CLARIFICATION OF TRAFFIC AND TRANSPORT MATTERS

ADDITIONAL INFORMATION:
ENVIRONMENTAL IMPACT STATEMENT

**GOLD COAST QUARRY
ADDITIONAL INFORMATION TO THE ENVIRONMENTAL IMPACT STATEMENT**

Title	Gold Coast Quarry Project - Old Coach Road/Bridgman Drive Concept Layout		
Client	Boral Resources (QLD) Pty Limited	Project No	CEB06354
Date	19 August 2013	Status	Final
Author	Damien Scutt/Nathan Edwards	Discipline	Traffic and Transport
Reviewer	Jeffrey Baczynski	Office	Brisbane

Figure 1 Study Intersection SIDRA Layout – Existing Configuration**Figure 2 Study Intersection SIDRA Layout - Potential Upgrade Configuration**

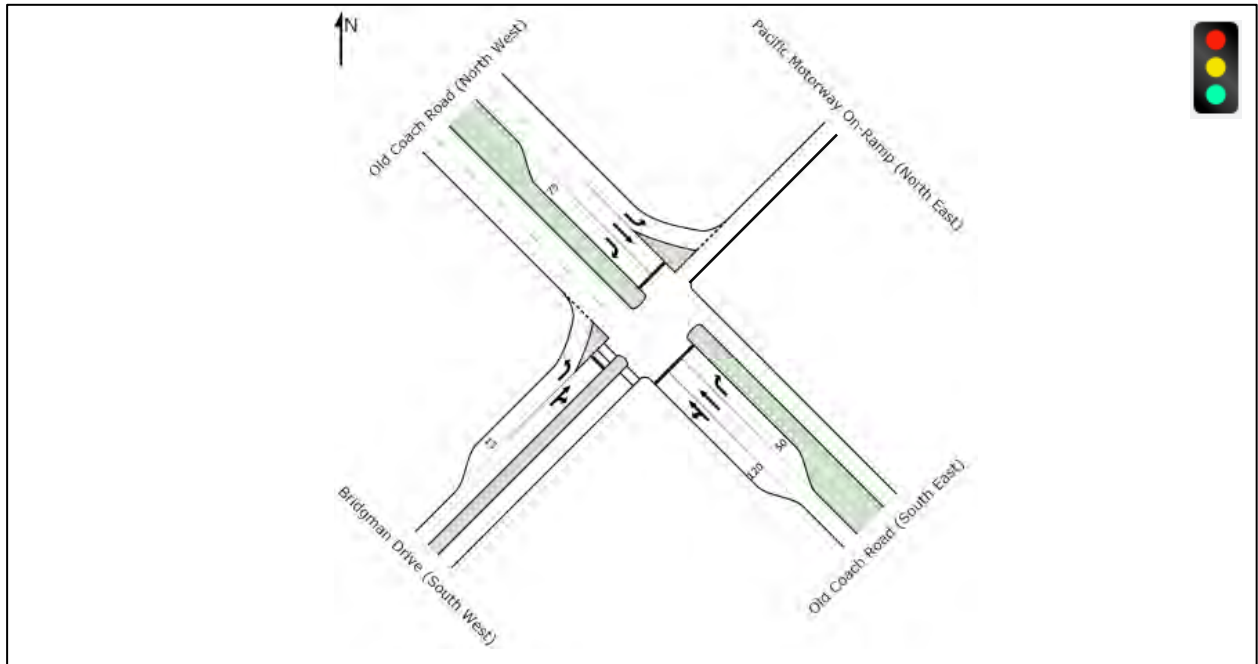
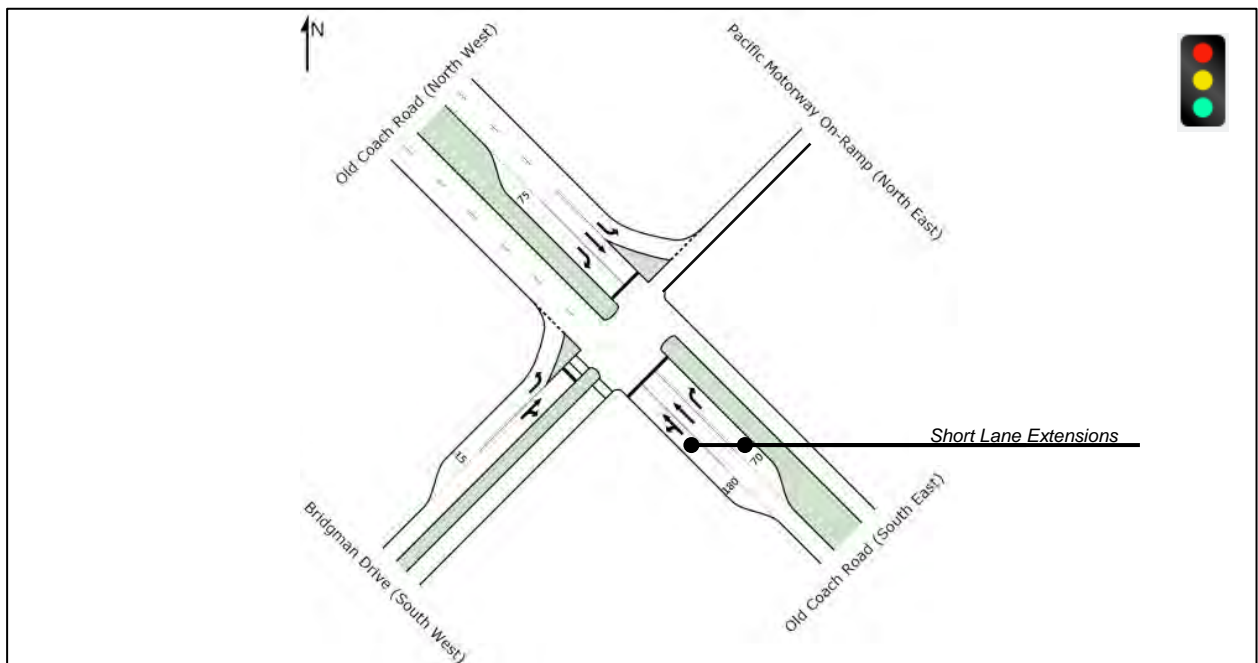
The potential upgraded configuration identified involves extending the approach lanes on the south-eastern approach to the intersection (i.e. Old Coach Road). Since issuing the RIA, TMR has raised concerns that the potential upgraded configuration may not be able to be constructed within the existing road reserve at this location. To inform TMR's assessment of the application, Cardno has prepared a high level concept layout of the potential upgraded configuration at the study intersection.

As shown on the concept drawing (refer Attachment T1.1), the potential upgraded configuration can be accommodated entirely within the existing road reserve. It is noted that there is a significant embankment on the south-western side of Old Coach Road. As a result, the concept layout assumes widening of Old Coach Road would occur on the north-eastern side where there is sufficient width. Nevertheless, the concept drawing should provide TMR confidence that the potential upgraded configuration identified within the RIA is achievable.

Figure 2-1 State-controlled Old Coach Road (north) Identified Issues

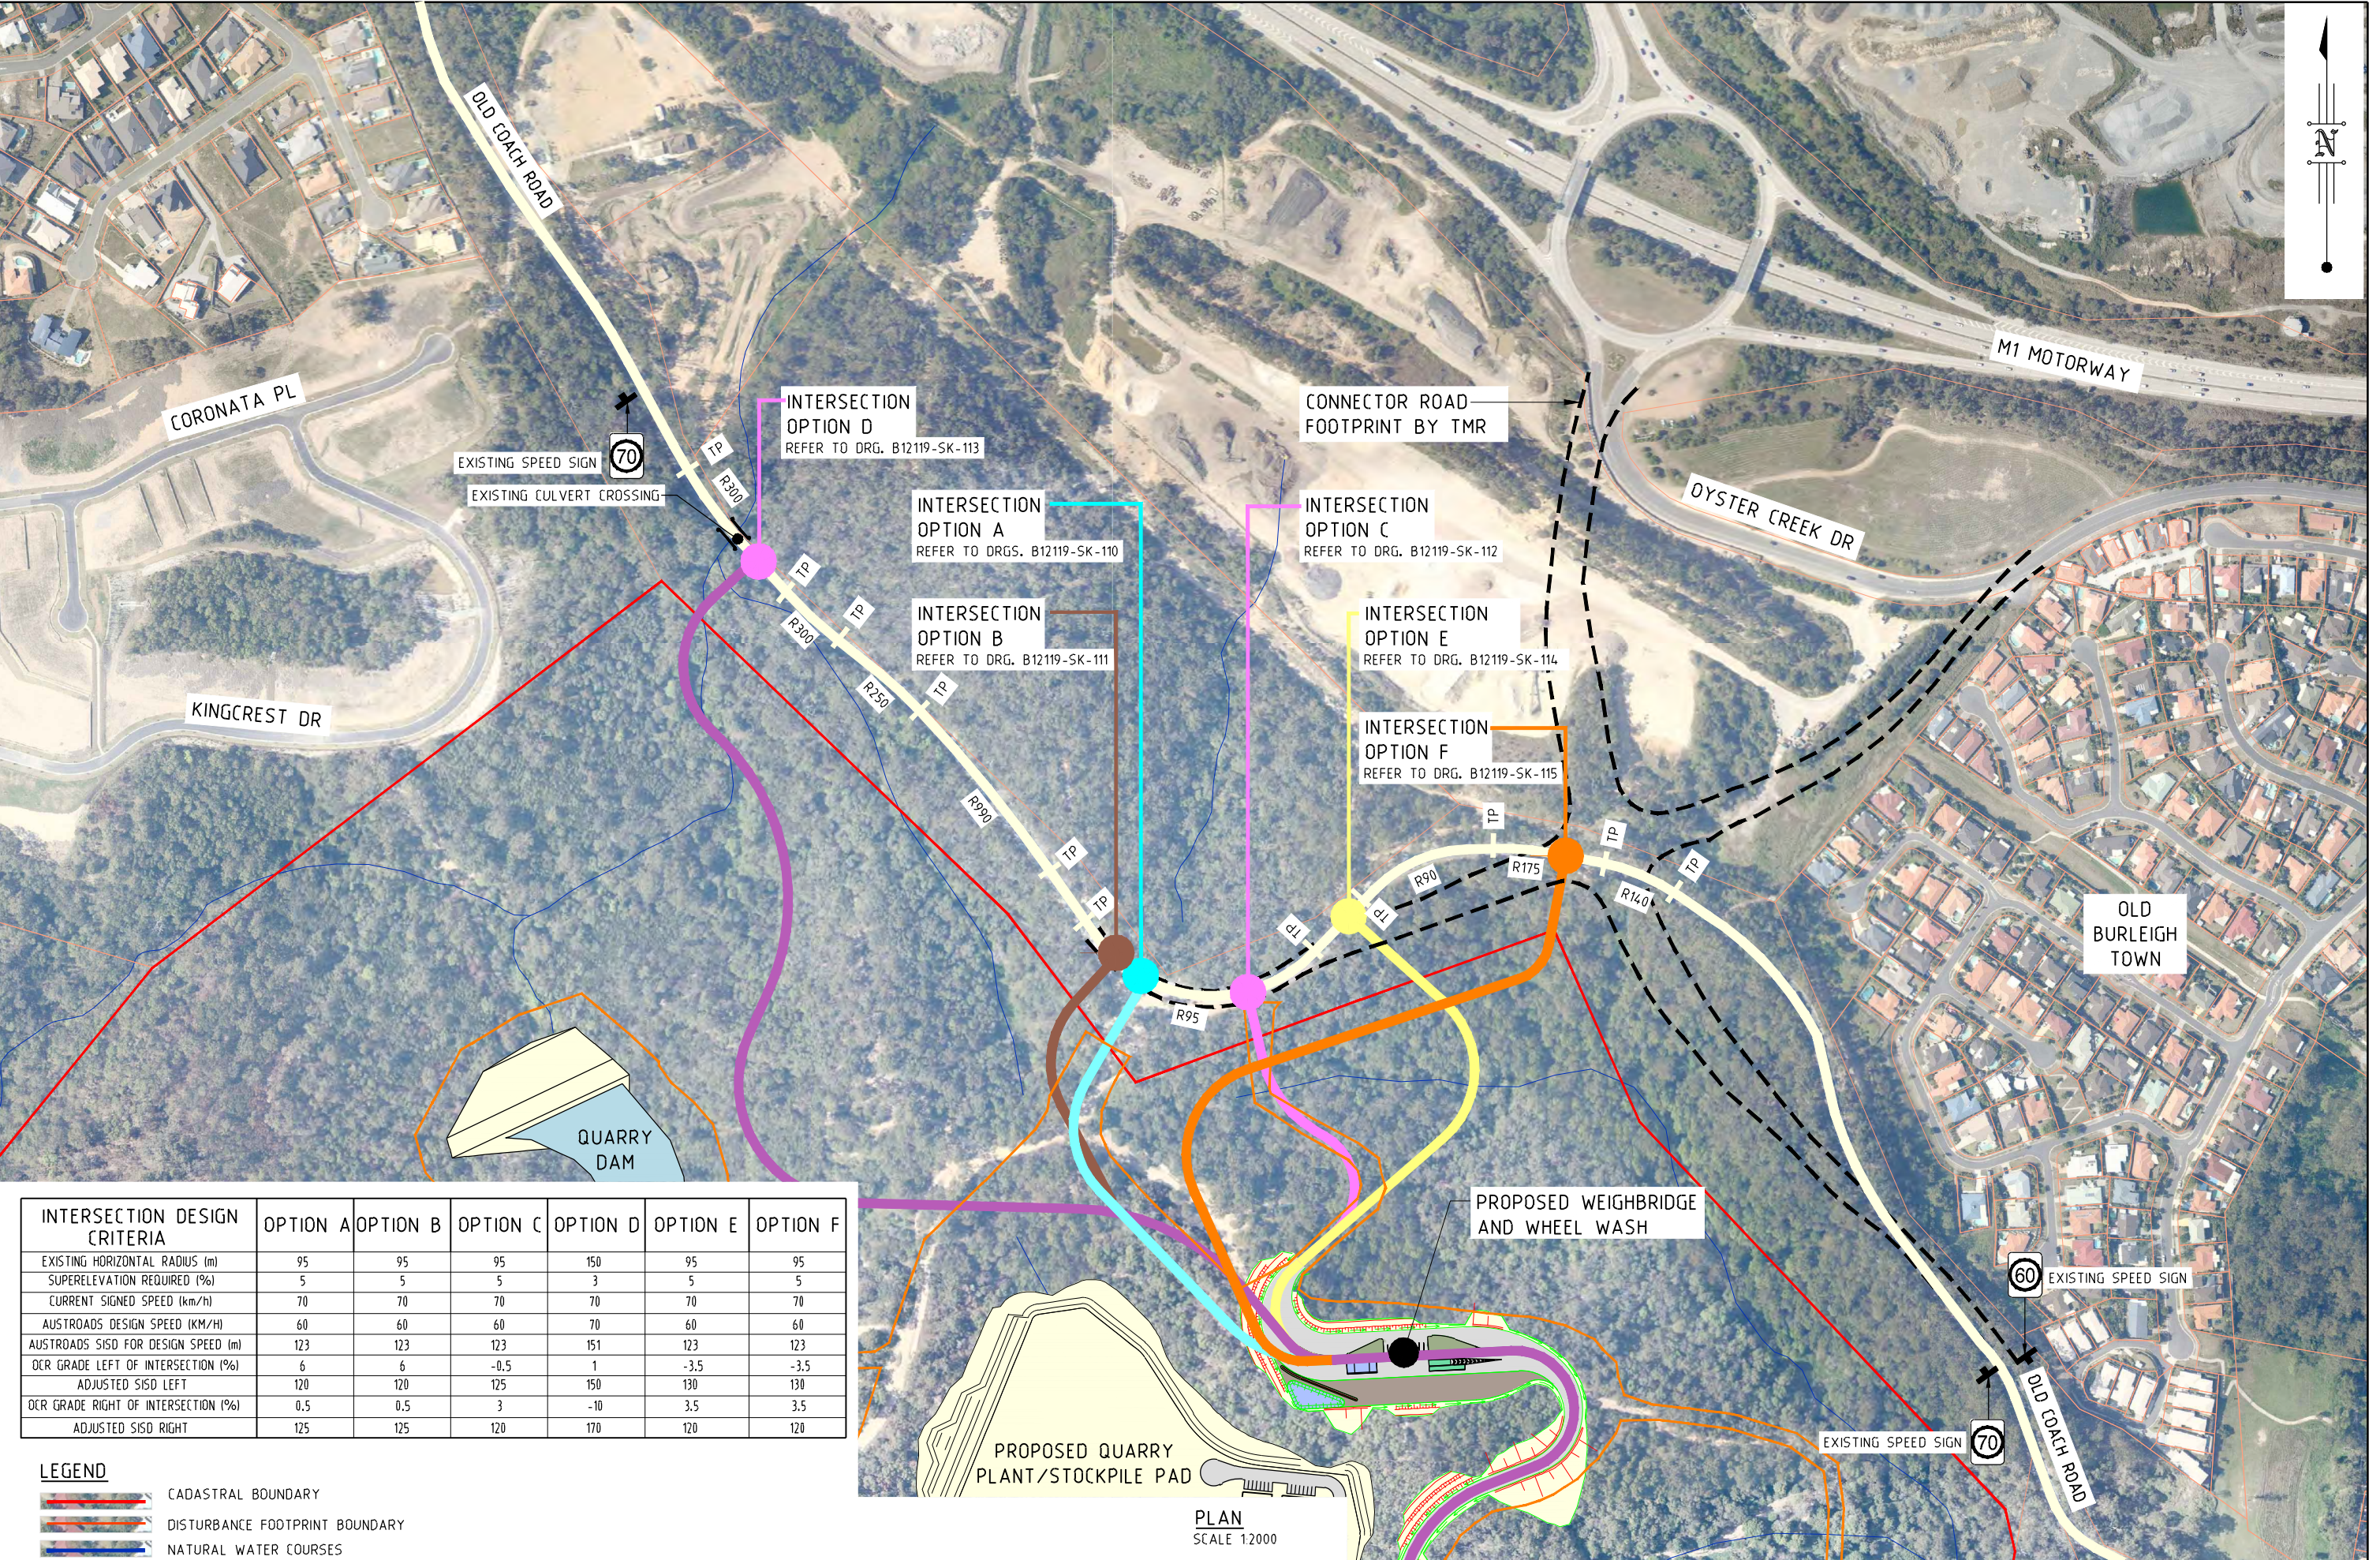
Location	Old Coach Road (northern approach) left turn slip lane to the northbound Pacific Motorway on-ramp, at the Old Coach Road/Bridgman Drive/On-ramp intersection		
Deficiency	Give Way line faded		
Risk	Vehicles may not perceive the need to give way at this location, with failure to give way potentially causing conflict with other vehicle movements.		
Recommendation	Repaint the Give Way line or consider using a thermoplastic material to reduce maintenance frequencies		
Priority	Low	Boral Presence	No

Location	Bridgman Drive approaching the Old Coach Road/Bridgman Drive/ On-ramp intersection		
Deficiency	Only three signal lanterns are provided for the through and right turn movements on the northbound approach		
Risk	May not provide a sufficient level of redundancy for the northbound movement		
Recommendation	Consider providing one additional lantern for the northbound approach signal group		
Priority	Low	Boral Presence	No

Location	Woodland Drive approaching the Old Coach Road/Woodland Drive intersection		
Deficiency	Stop sign rotated and Stop line faded		
Risk	Risk that vehicle may not detect the presence of the intersection or may not pay sufficient attention (as it may be considered as a Give Way controlled intersection)		
Recommendation	Re-orientate the Stop sign and repaint the Stop line (give consideration to using a thermoplastic material)		
Priority	Medium	Boral Presence	No

Location	Old Coach Road (northbound approach) to Old Coach Road/Kingsmore Boulevard/Off-ramp roundabout (approximately 150m in advance of the roundabout)		
Deficiency	Reduction in speed from 70km/h to 60km/h occurs on a curve and in close proximity to the reverse curves on the approach to roundabout		
Risk	Drivers may not have sufficient time to respond to the change in speed limit prior to negotiating the curves on approach to the roundabout		
Recommendation	Considering relocating the speed limit signage and pavement markings upstream to the straight section of Old Coach Road immediately prior to curve		
Priority	Low	Boral Presence	Yes

Location	Old Coach Road (northbound approach) to Old Coach Road/Kingsmore Boulevard/Off-ramp roundabout (approximately 150m in advance of the roundabout)		
Deficiency	Roundabout advisory sign is faded and offers a poor level of retro-reflectivity		
Risk	Drivers may not see the advisory sign at night or under adverse weather conditions and fail to anticipate the approach curves to the roundabout		
Recommendation	Replace sign		
Priority	Medium	Boral Presence	Yes

Location	Left hand side of Old Coach Road (northbound approach) to Old Coach Road/Kingsmore Boulevard/Off-ramp roundabout (approximately 20m prior to roundabout)		
Deficiency	Sharp drop off and unprotected culvert headwall located immediately outside the shoulder (within the clear zone)		
Risk	If an errant vehicle left the road at this location, there is a risk of loss of vehicle control		
Recommendation	Consider installing guardrail to shield the hazard		
Priority	Medium	Boral Presence	Yes

Location	Old Coach Road (northbound approach) to Old Coach Road/Kingsmore Boulevard/Off-ramp roundabout		
Deficiency	Median vegetation has grown to a height where it obscures the approach view of circulating traffic on the roundabout for approaching light/passenger vehicles		
Risk	Northbound vehicles may fail to observe/give way to circulating traffic on the roundabout, resulting in conflict/collision		
Recommendation	Trim the vegetation to a maximum height of 800mm above the road surface so that northbound drivers (in light vehicles) can observe circulating vehicles and their turn signals. Regularly maintain the vegetation to ensure that it does not grow high enough to obscure sight lights.		
Priority	Medium	Boral Presence	No

Location	Old Coach Road/Kingsmore Boulevard/Off-ramp roundabout		
Deficiency	Street lights in the middle of roundabout were not working		
Risk	Driver perception of the roundabout may be reduced at night time, increasing the potential for vehicles to fail to reduce approach speed or give way as required		
Recommendation	Repair street light		
Priority	Medium	Boral Presence	Yes

Location	Pacific Motorway northbound off-ramp (Exit 85)		
Deficiency	No guardrail present at the hairpin turn from the off-ramp (Exit 85)		
Risk	If an errant vehicle left the road on the hairpin, there is a risk of loss of control of vehicle or collision with the vegetation on the outside of the curve. It is likely that the existing vegetation will continue to grow and greater trunk diameters will pose an increased risk in the event of collision		
Recommendation	Consider installing guardrail along the outside of the hairpin curve		
Priority	Med	Boral Presence	Yes
